HISTORIC AND DESIGN REVIEW COMMISSION

June 2, 2021

HDRC CASE NO: 2021-218
ADDRESS: 2119 N IH 35
LEGAL DESCRIPTION: NCB 1274 BLK 6 LOT 6
ZONING: C-1, H
CITY COUNCIL DIST.: 2
DISTRICT: Government Hill Historic District
APPLICANT: Hector Solis (Cerveceria 88) & Pedro Ramo (PR Custom Signs)
OWNER: JD Ibarra/G&S INTERESTS LLC
TYPE OF WORK: Signage
APPLICATION RECEIVED: April 29, 2021
60-DAY REVIEW: Not applicable due to City Council Emergency Orders
CASE MANAGER: Huy Pham

Front lit plex-face internally illuminated whit led's channel letters- reaway mounted

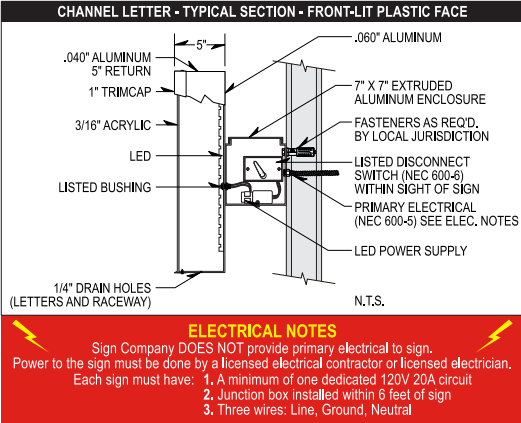
- c. SIGNAGE – The applicant has proposed to install two (2) 38.5 square-foot roof top signs, one (1) 2 square-foot blade sign on the front porch column, and a number of window decals and vinyl banners throughout.

- d. SIGN SIZE & NUMBER – Per the Guidelines for Signage 1.A.i., each building will be allowed one major and two minor signs and total requested signage should not exceed 50 square feet. Staff finds the proposed signage is inconsistent with the Guidelines by featuring two major signs and one minor sign, and a total square footage of approximately 79 square feet excluding the window and banner signs. Staff finds that one of the main roof top signs should be removed – or the total signage plan should be reduced and revised, and that all window decal and vinyl banners be removed.

- e. SIGN LOCATION – The applicant has proposed to locate the two main signs on the non-original roof top of the expanded porch and the blade sign on the front porch column. Per the Guidelines for Signage 1.C.i., applicants should place signs where historically located and reuse sign attachment parts where they exist and avoid erecting signs above the cornice line or uppermost portion of a facade wall, or where they will disfigure or conceal architectural details, window openings, doors, or other significant details. Staff find that the rooftop signage is prohibited per the Guidelines for Signage 1.F.i. and should be removed.

- f. SIGN DESIGN – The proposed roof top signs features 3 bases colors, internally illuminated acrylic channel lets, on a raceway skid and the blade sign features an internally illuminated round cabinet face with 2 mounting arms. Staff finds the proposed signage is inconsistent in material and lighting. The signage should feature wood, wrought iron, steel, aluminum, and metal with indirect or bare bulb lighting.

SIGN: Both was support of general sign type, lighting, and individual sizes based on existing highway/franchise commercial neighbors. However, suggested that one of the two roof top signs should be removed, and the remaining sign should be oriented diagonal toward the highway. All other signage such as branded umbrellas, banners, flags, and circle blade sign should be removed.

Staff does not recommend approval of item 1. signage as proposed based on findings b through f regarding total square footage, material, illumination, and prohibited sign type (new roof mounted sign). Staff recommends the signage plan is reduced and revised per the Guidelines for Signage before resubmission.

STAND ALONE STAGE

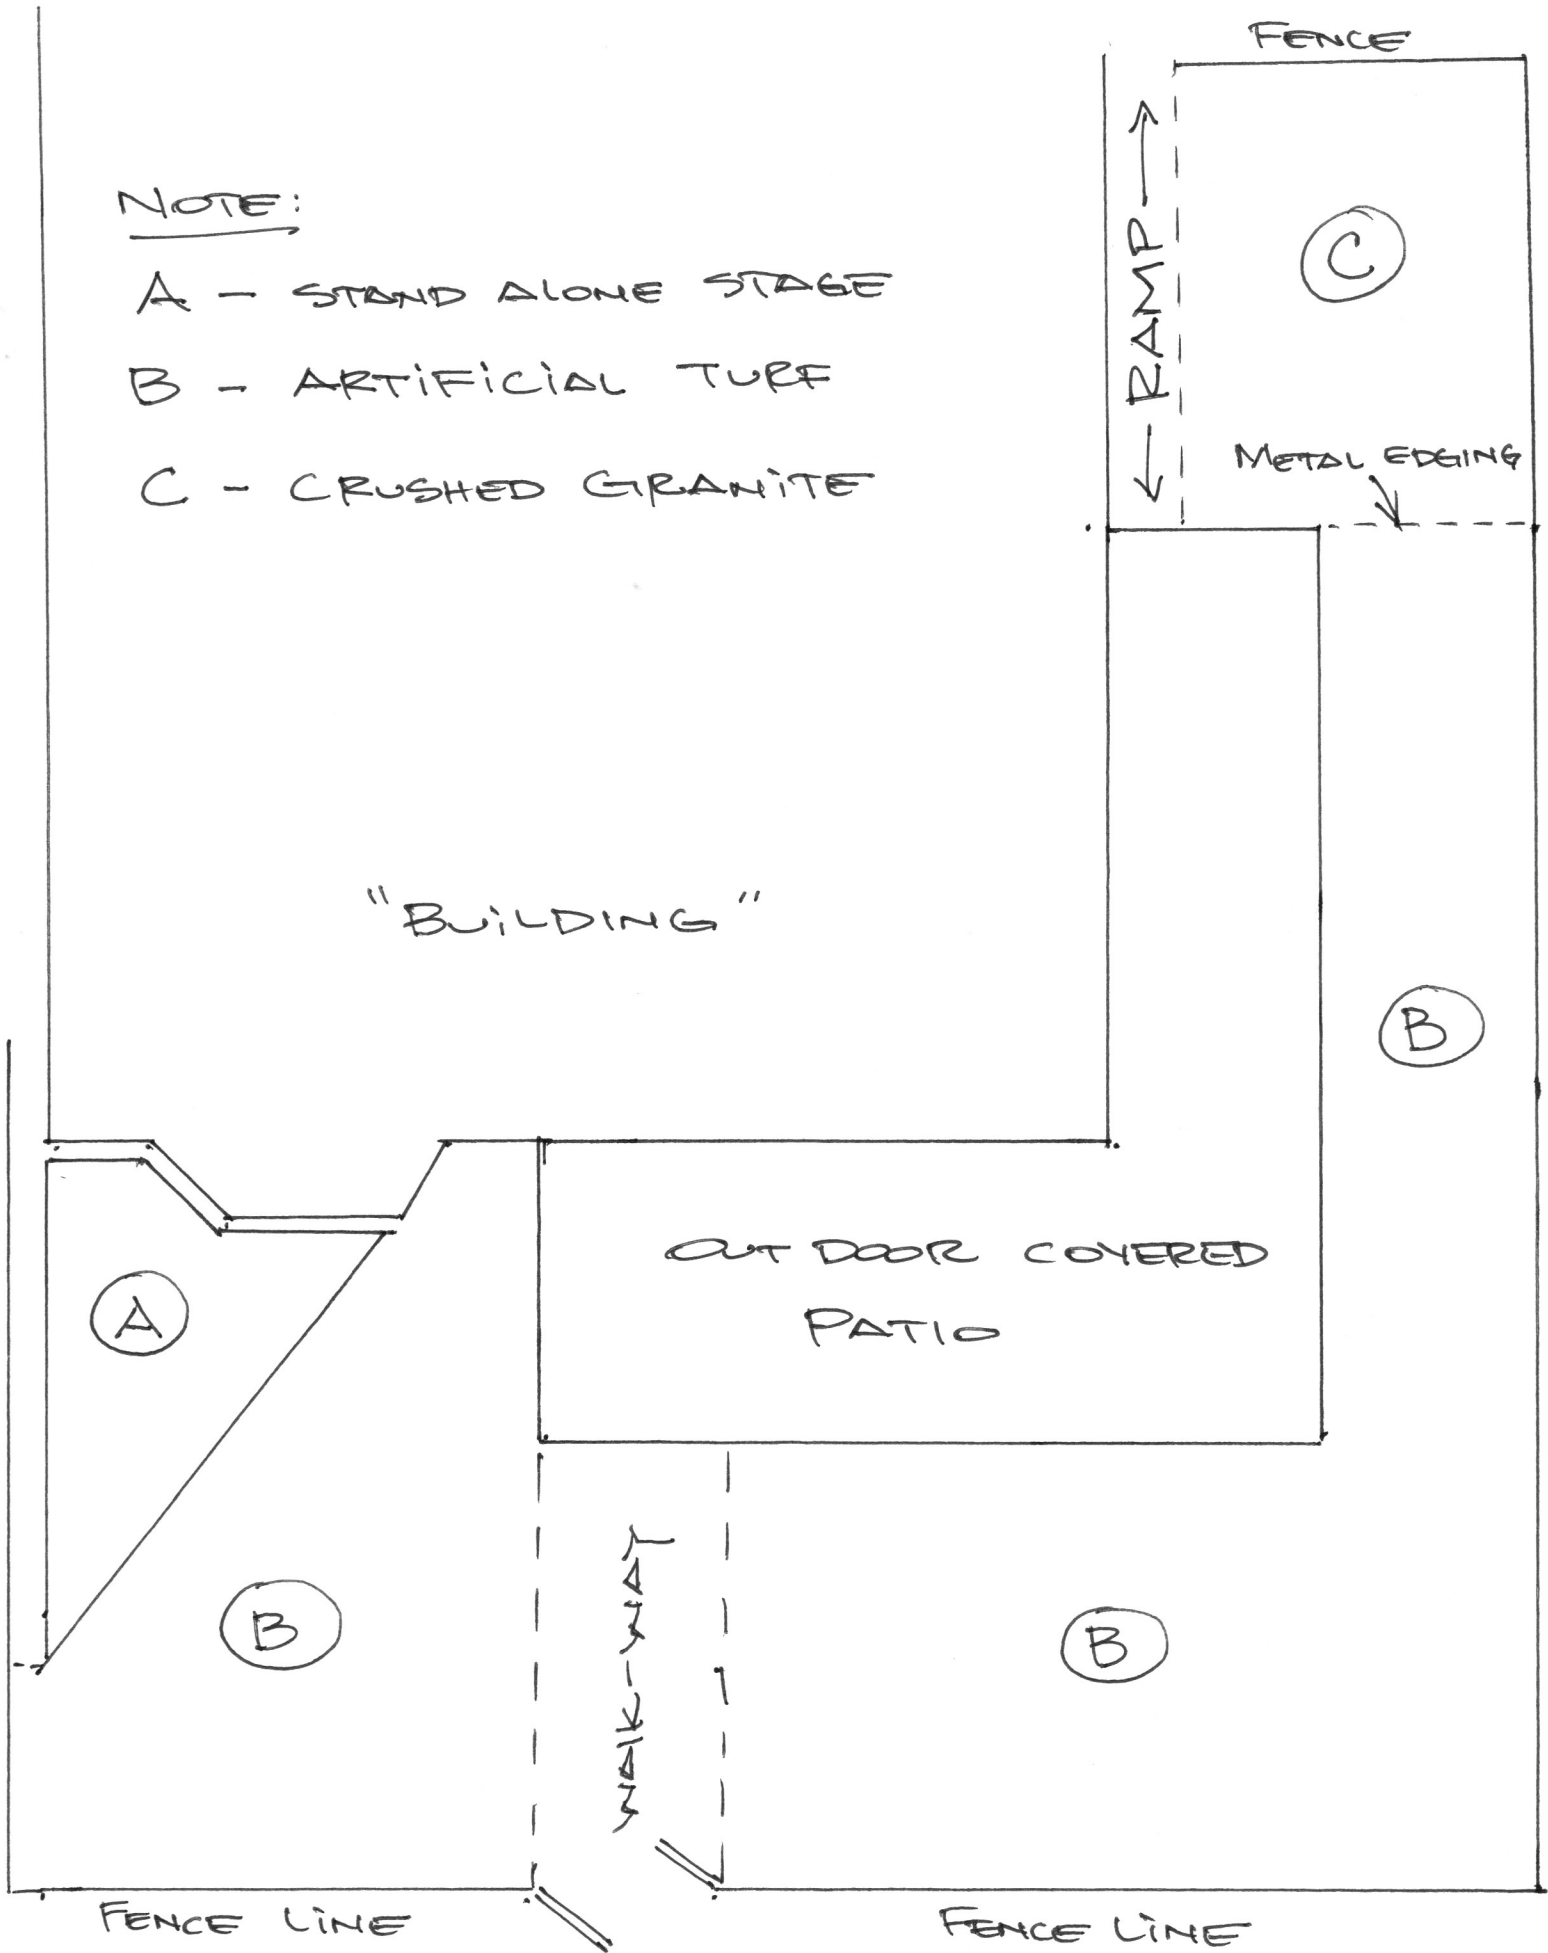
- g. STAGE – The applicant has proposed to construct a 20-foot wide, 10-feet tall triangle wood stage with a green wall for noise reduction. Staff finds the placement and height of the stage obstructs the bay window, which is one

of the few remaining character-defining features of the structure. Staff finds that the stage should be relocated to area that does not any primary historic features such as the rear yard or reduced in size in a different front yard corner. The applicant is responsible for comply with any noise or use restrictions or other related building code per the designated zoning.

STAGE: Both were concerned about setback from the neighboring property line and overhead structure. The suggested smaller free standing stage that has been administratively approved before.

Staff does not recommend approval of item 2. Stage construction based on finding g. Staff recommends that the stage is relocated to area that does not obscure any primary historic features such as the rear yard or reduced in size in a different front yard corner. The applicant is responsible for complying with any noise or use restrictions or any other related building code per the designated zoning.

Porch

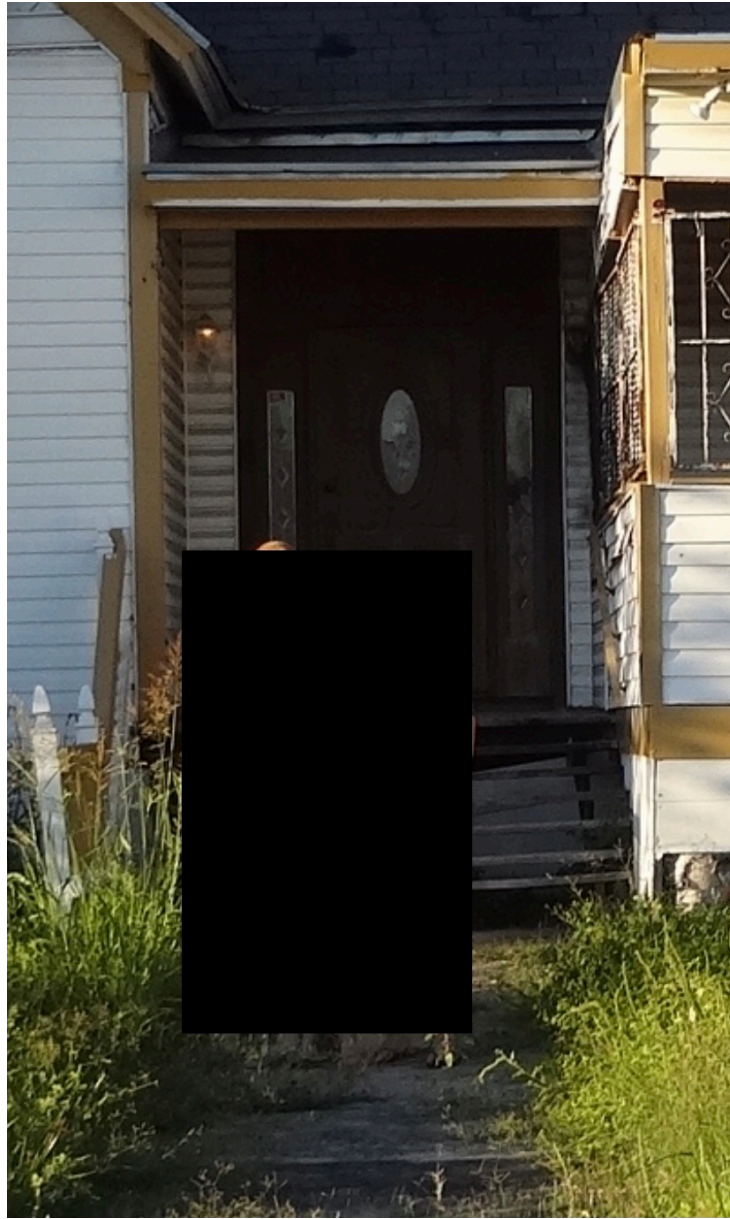
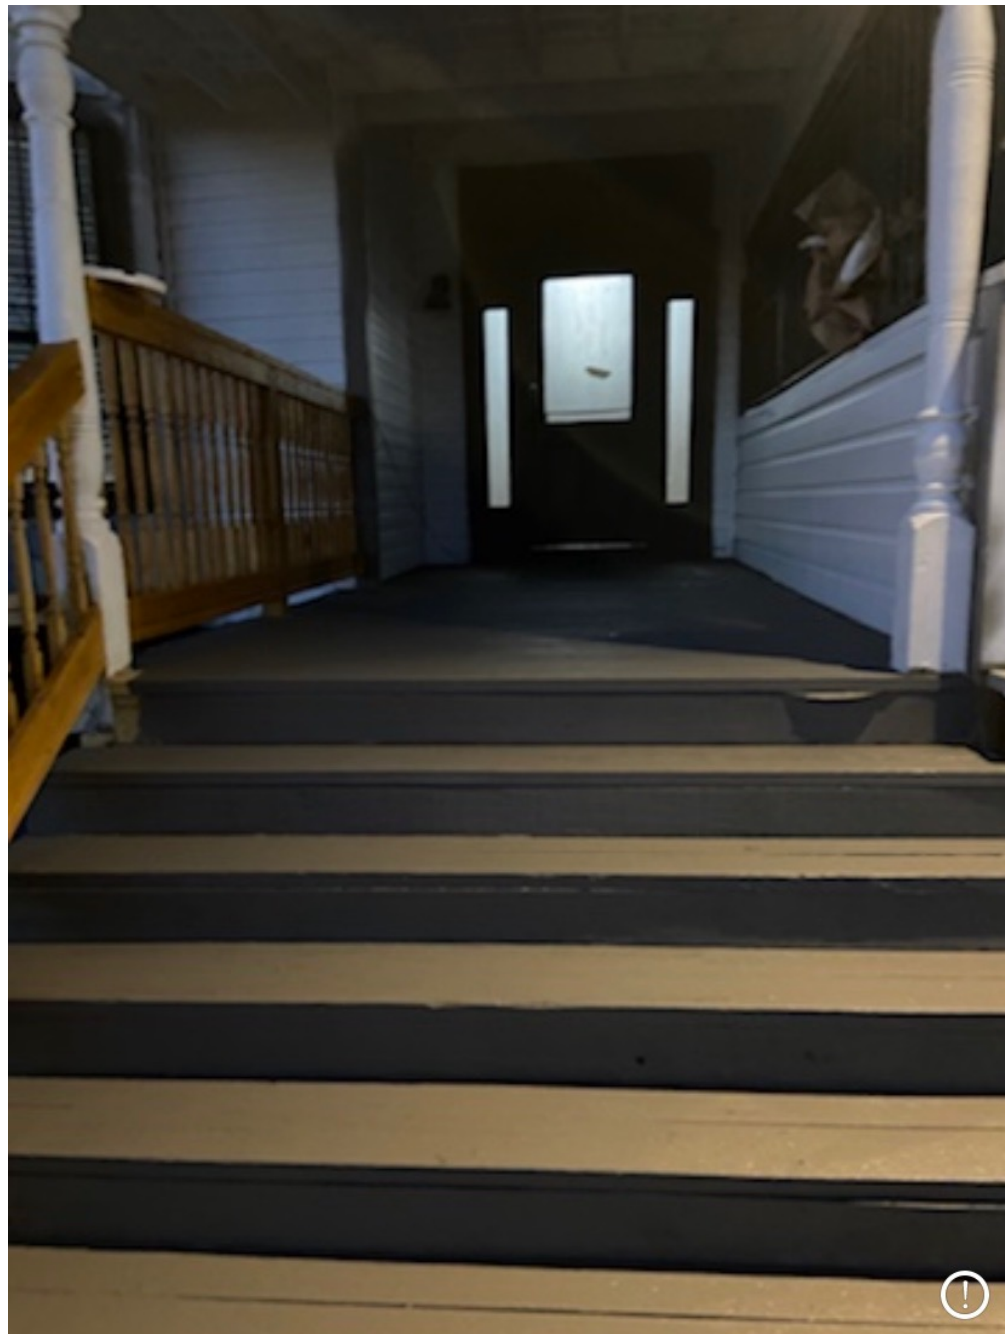
- h. PORCH MODIFICATIONS – The applicant has proposed to expand the front covered porch with new shed roofing, columns, steps, and attached wood box. Staff finds the proposed modifications are inconsistent with the Guidelines for Exterior Maintenance 7.A.i through B.v and should be restored to its original size configuration, and material based on photographic evidence.

PORCH: Fish noted that he was part of consultation years ago, two owners/tenants prior, and that the front porch as seen in the 2019 photos may have already been an extension from the original farther recessed porch. Fetzter and Fish were supportive to the fact the applicant used found columns and stairs on site, but remained concerned about finishing details such as railing and upside down column.

Staff does not recommend approval of item 3. porch modifications. The porch should be restored to its original size configuration, and material based on photographic evidence.
